CITY OF SACRAMENTO
1231 I Street, Sacramento, CA 95814

Site Address: 841 38TH ST SAC
Parcel No: 841-0032-037

Nature of Work: REMODEL, ADDITION. 900 SQ. FT. FIRST FLOOR. 2ND FLOOR 900 SQ. FT.

REVISION M

I. OVERCUT IN WALL STUDS
FOR 3" WASTE VENT

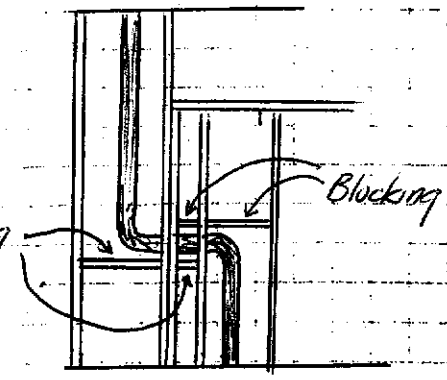
EVEN THOUGH STUDS WERE DRILLED BEYOND THE MAX.
PER CODE, THE WALL CARRIES MINIMUM LOAD PER
CALCS:

HOWEVER - MICRO RIM JOIST

CARRIES LOAD

$$I = 5(420)(12)(9 \times 12)^4 / 384(1.9 \times 10^6)(.30) = 108.70 \text{ IN}^4$$

1 3/4 x 11 1/4 MICROLAM RIM JOIST WILL

CARRY ALL OF THE LOAD ABOVE.

SO THERE IS VIRTUALLY NO LOAD

ON CUT STUDS - RECOMMENDATION:

SOLID BLOCKING AS SHOWN TO
STIFFEN UP STUDS IN SIDEWAY
DIRECTION.

EXTERIOR PLYWOOD/STUCCO
WILL STIFFEN IN FRONT
TO BACK DIRECTION AND
THIS WILL BE SATISFACTORY

II. NOTCH IN TOP OF FLANGE

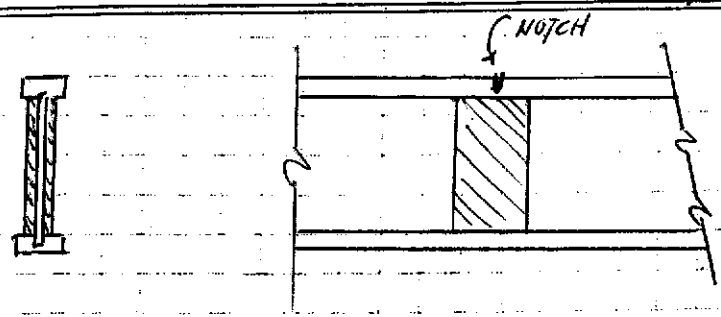
IN CUTTING A VENT HOLE THROUGH UPPER
FLOOR, A SLIGHT CUT WAS MADE INTO THE TOP
FLANGE OF A TIE @ THE CORNER OF THE BATHROOM

THE NOTCH, FORTUNATELY OCCURS DIRECTLY ABOVE THE
SUPPORTING WALL SO IT SHOULD NOT PRESENT A
STRUCTURAL PROBLEM

RECOMMENDATION: BLOCK THE WEBS ON BOTH SIDES
OF TIE AT NOTCH FOR ADDED PROTECTION, USING $\frac{3}{8}$ x 4" WIDE
PIECES MIN.

TRUSS REPAIR FOR HVAC

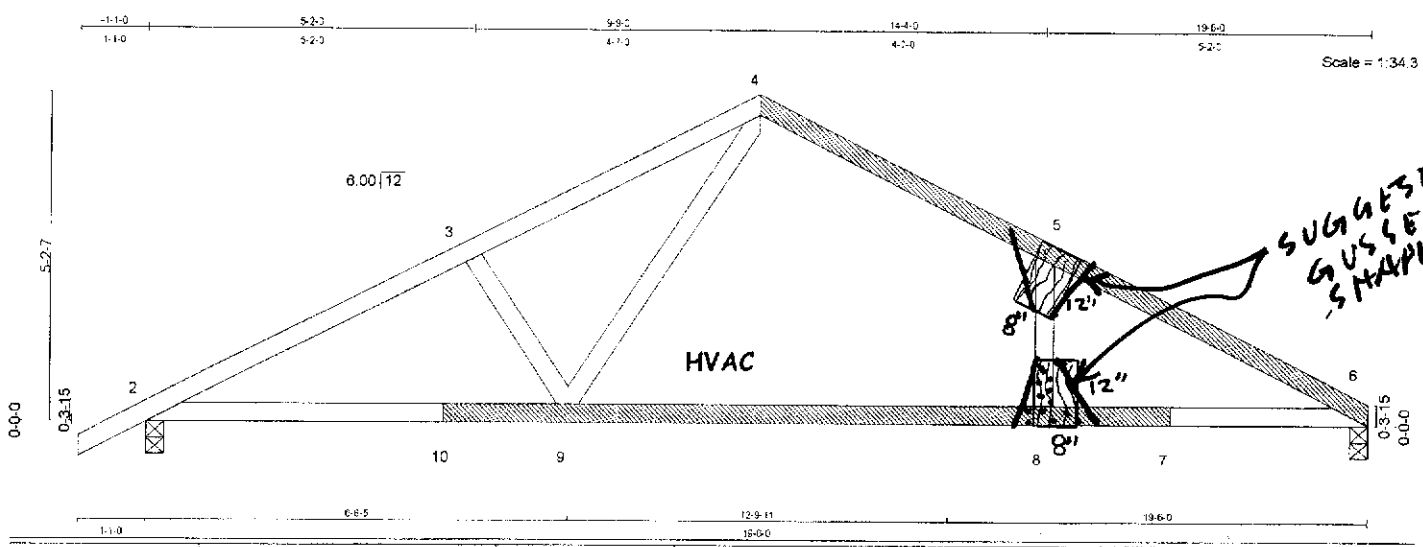
- This truss has been designed with ANSI/TPI 1-1995 criteria.
 - REPAIR NOTES when truss webs removed;
 - Truss repair calculations based on information from fabricator/contractor whose responsibility it is to verify the adequacy of repair as to its field application. Return all joints to original position before applying repair. The end distance, edge distance, nail spacing, and size of plywood gussets and/or truss members shall be such as to avoid splitting of the wood.

- Using 10d nails staggered 6" oc, attach to one side of the top chord an equal grade and size SCAB as shown.
 - Using 10d nails staggered 6" oc, attach to one side of the bottom chord an equal grade and size SCAB as shown.

- Field-fit 2x4 #1&Btr DF web 5-8 using 3/4" CDX plywood one side of truss, 12-8d each member each end as shown. Obtain wood-to-wood tight-fitting joints.

Perforated Shearwall: Front Elevation, Entry wall, left of door Project: Odem, 38th St
D. Rt/Lt Lateral Forces, Level 1, Forward Bldg Portion

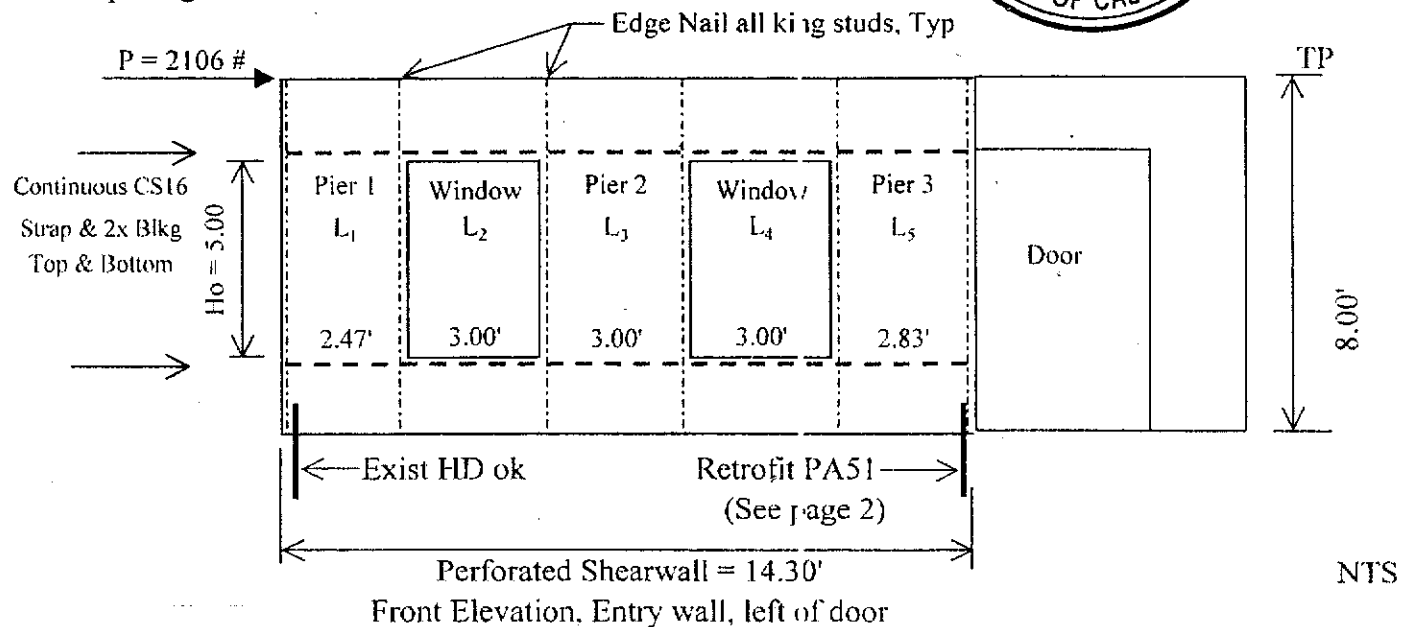
REVISE LOCATION OF DOORS & WINDOWS AT FRONT ENTRY WALL
REVISED PERFORATED SHEARWALL DESIGNATION AT FRONT ENTRY WALL

- 1 Provide structural panel sheathing, Shearwall Type 1.
- 2 Set continuous Simpson CS16 strap to the interior face with 8d @ 4" OC, across continuous 2x blocking at the line of both the window sill and header, adjacent to openings.

RETROFIT HOLDOWN DETAILS

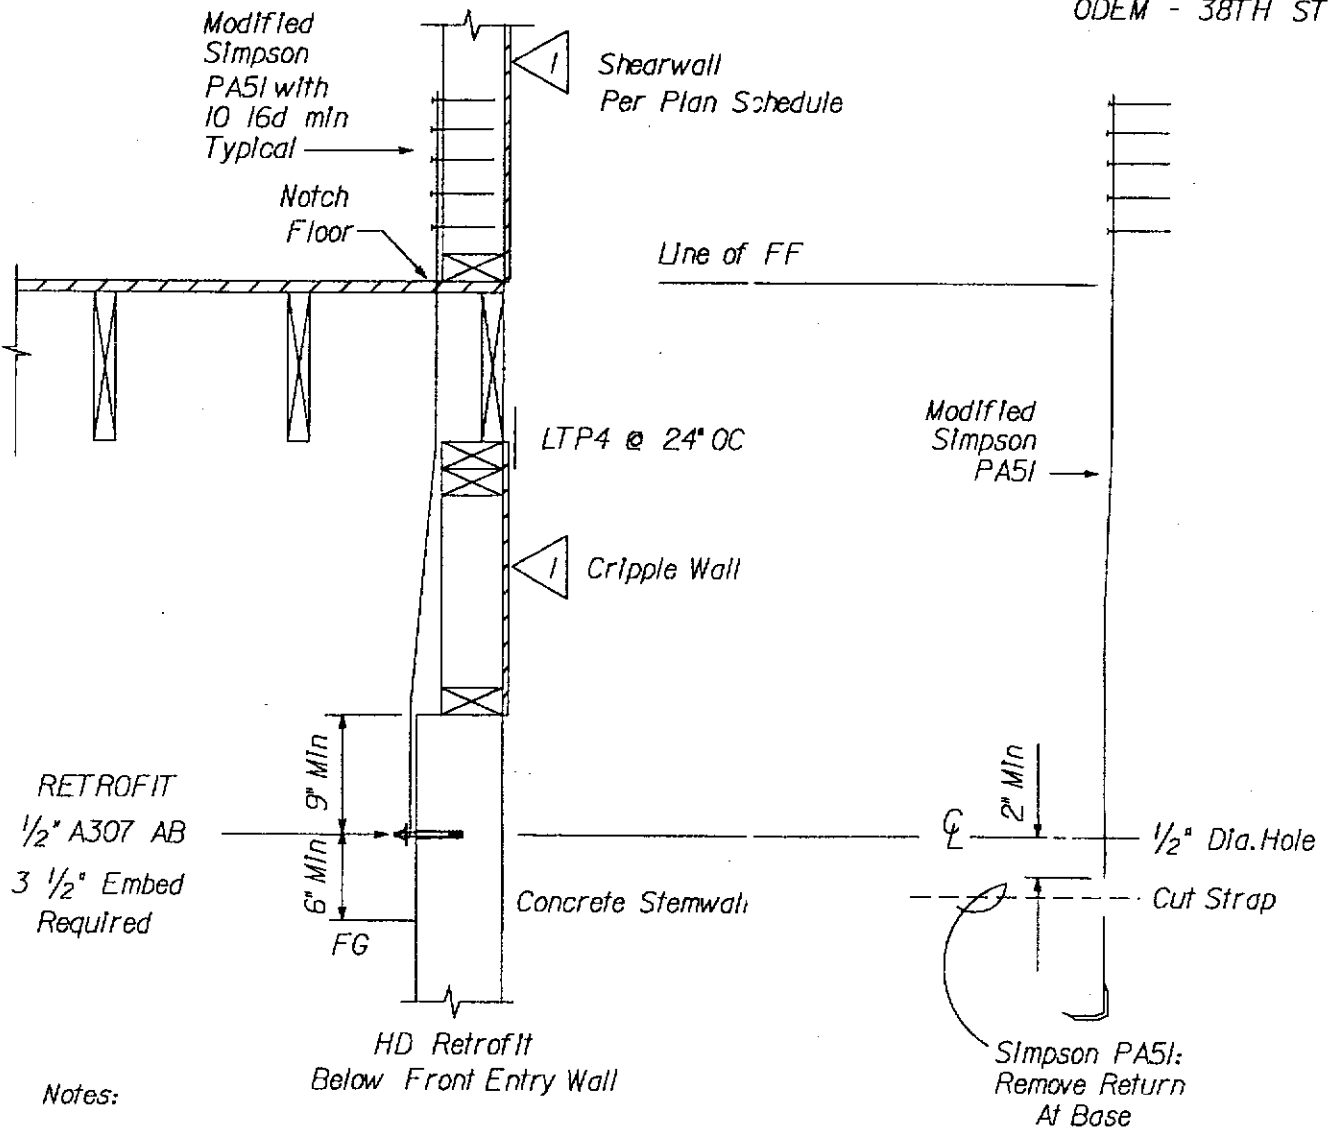
1. Front Elevation	% Trib	Wall	
Unit Base Shear: 147 plf	60%	* Uplift	Anchor Spec Shear Use Shear Wall
Shear wall = 14.30'	*Lt side front door	999 #	** PA51 2106 # Type 1
Total L = 14.30'	* see perforated shearwall calc at end of section		
	** see detail attached for retrofit adjacent to door.		
	Existing holdown at left corner ok.

One 1/2" AB required to retrofit modified PA51 to stemwall below.

Retrofit HD Set Simpson PA51 strap to interior or exterior face of stemwall with one 1/2" AB.
 (Max strap capacity 3685#)
 10 16d required in double 2x or 4x above for 1287.lbf tension load.

PA51 AB Options: 1/2" Simpson 'Wedge All' or 'Drop In', min embedment 3.5". Ref ICBO ER 3632
 1/2" Rawl 'Power Bolt'. Min embedment 3.5". Ref ICBO ER 5225
 Install retrofit bolt per manufacturers specifications. See 'Concrete Notes' 13 / S1.

1. See Details 6 & 12, Sht SI, for nailing requirements to framing members.
2. Set retrofit AB per 'Concrete Notes', 13 SI.
3. PA51 may be set to either face of stemwall to facilitate placement.
